WATER QUALITY MEMORANDUM

Utah Coal Regulatory Program

RE: Third Quarter 2015 Water Monitoring, PacifiCorp, Deer Creek Mine.
C/015/0018, Task ID #4993

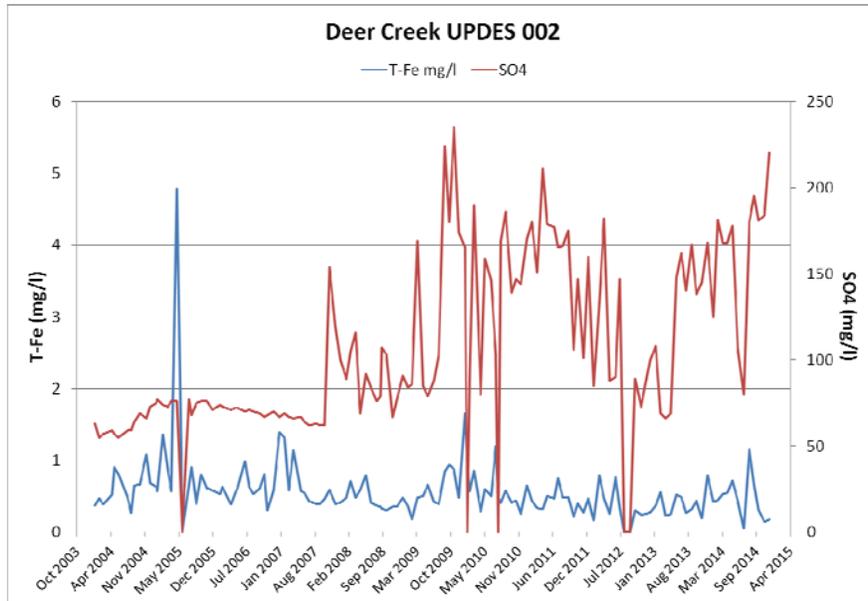
Listed parameters are more than two standard deviations above the mean.

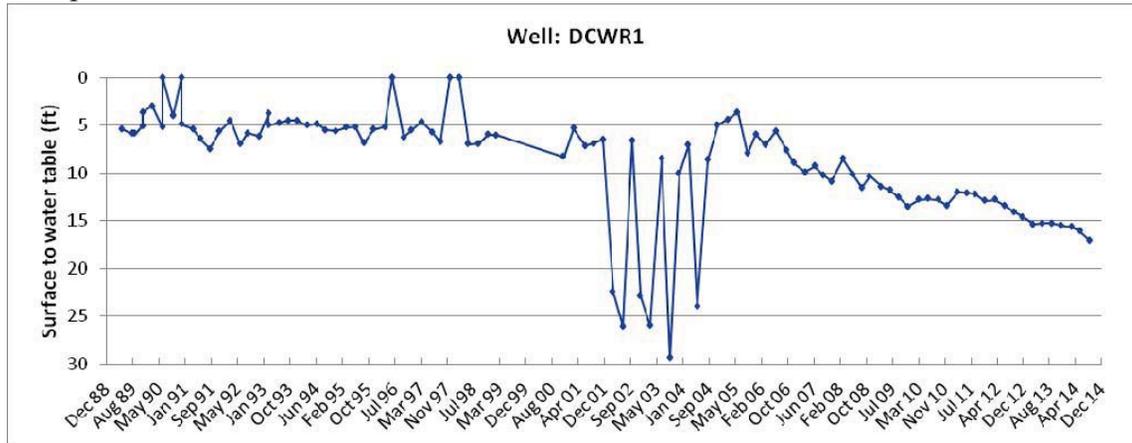
The Deer Creek Waste Rock well has been dropping since 2006 (following a small rise in 2004-2005). These changes are probably from factors other than disposal of waste rock at this

site: a similar drop in water level is seen at WCWR1 at the Cottonwood/Wilberg Mine Waste Rock Disposal Site.

This well is no longer a Pacificorp water monitored site. It is now monitored by Bowie as the Deer Creek Waste Rock site.
